APPLICATION NO.	FILING DATE	FIRST NAMED INVENTOR	ATTORNEY DOCKET NO.	CONFIRMATION NO.
10/552,979	04/18/2006	Georges Driesen	02894-0727US1 / Z-7882Q	2159
27752 7590 09/09/2010 THE PROCTER & GAMBLE COMPANY Global Legal Department - IP Sycamore Building - 4th Floor 299 East Sixth Street CINCINNATI, OH 45202			EXAMINER DANIEL, JAMAL D	
			ART UNIT 3723	PAPER NUMBER
			MAIL DATE 09/09/2010	DELIVERY MODE PAPER

Office Action Summary	Application No. 10/552,979	Applicant(s) DRIESEN ET AL.	
	Examiner JAMAL DANIEL	Art Unit 3723

DETAILED ACTION

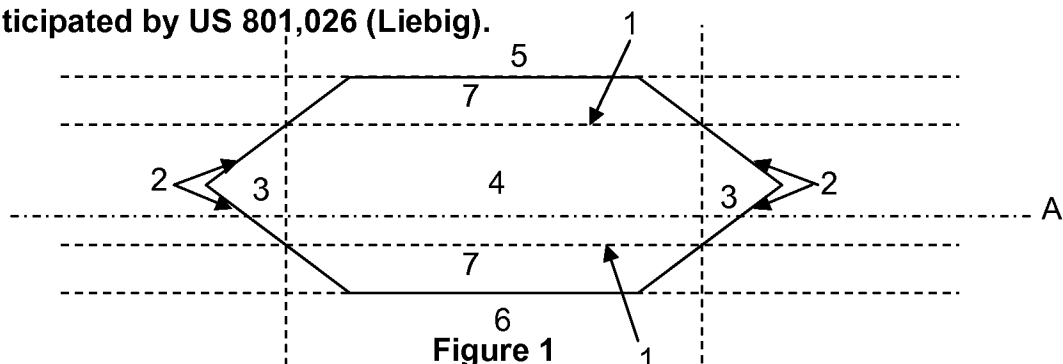
1. In re claims 1-3, 7, 9, 13, 15, 17, 18 and 23, with reference to figure 1 above, Liebig discloses a bristle cluster stuffing tool ram comprising broad longitudinal sides (1), face sides (2), and a pressing surface including: end face regions (3) and a central face region (4) being wider than the end face regions as measured between the broad longitudinal sides of the ram, a first broad longitudinal side (5) extending between ends of the face sides of the ram, and a second broad longitudinal side (6) extending between ends of the face sides of the ram such that a cross sectional area of the ram is asymmetric about a lateral axis (A) of the ram.

6. In re claims 4 and 6, Liebig discloses a trapezoidal projection, but it would have been an obvious matter of design choice to one having ordinary skill in the art at the time the invention was made to use a rectangular projection since both projections effectively serve the same purpose of adding thickness to the ram which increases said ram's strength and lessens the chance of breakage. A rectangular projection would inherently include a stepped transition.

8. Applicant argues that the cross sectional area of the ram of Liebig is not asymmetrical about a lateral axis. The Examiner disagrees. A specific lateral axis was not chosen. The axis (A) specified in the claim rejection is a lateral axis and thus the claim still reads on the reference.
